MDB2846 / MDB3365 → WVAs 24468 / 24469

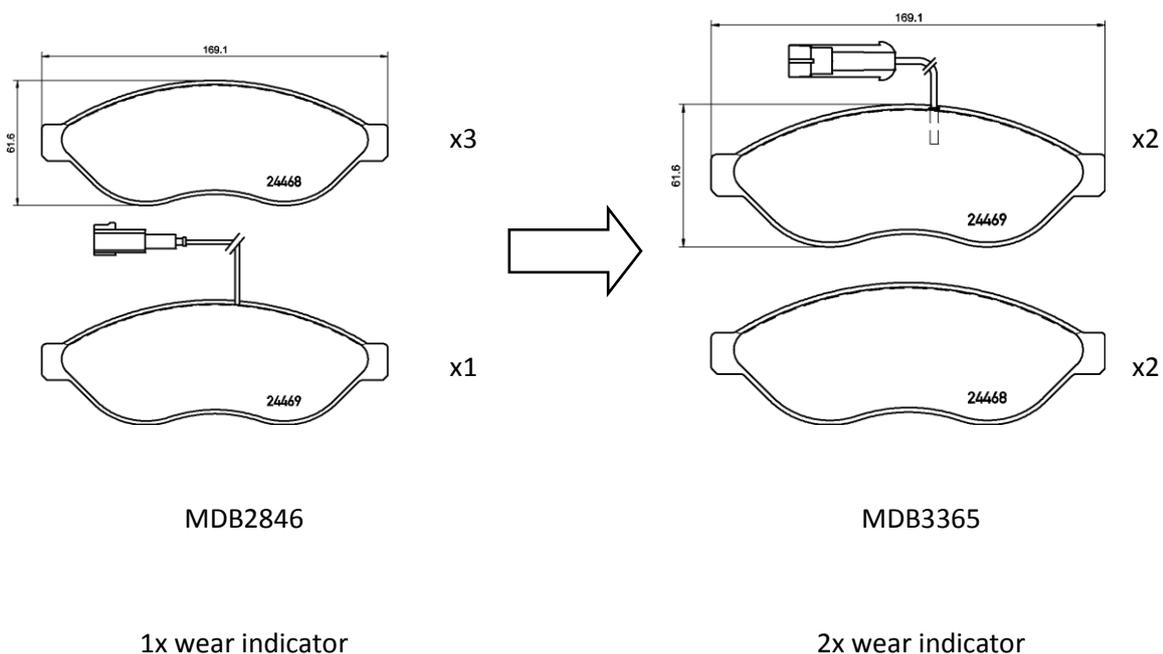
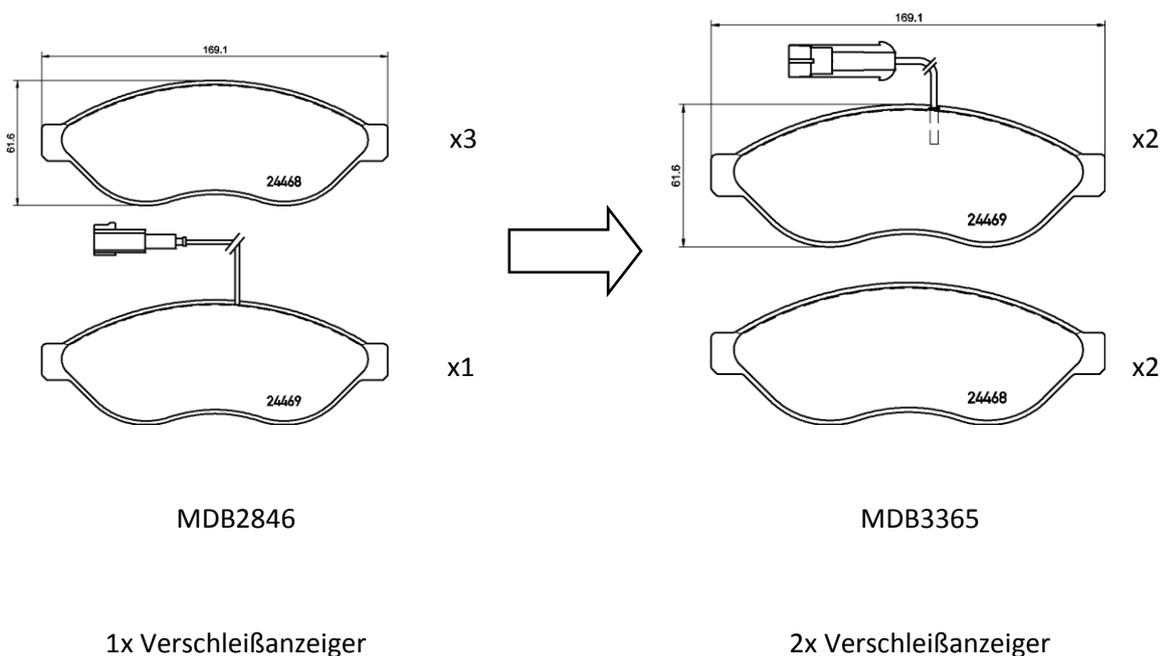
For the reference MDB2846 Fiat have changed their corresponding OES reference from one wear indicator to two wear indicators per set. Not used wear indicators have to be simply cut off during assembly.

In order to be in line with the OES programme we will do the same change. As a result of this we will replace MDB2846 by MDB3365.

Existing stock of MDB2846 can be sold out. Please take care that only vehicles equipped with one wear indicator can use MDB2846.
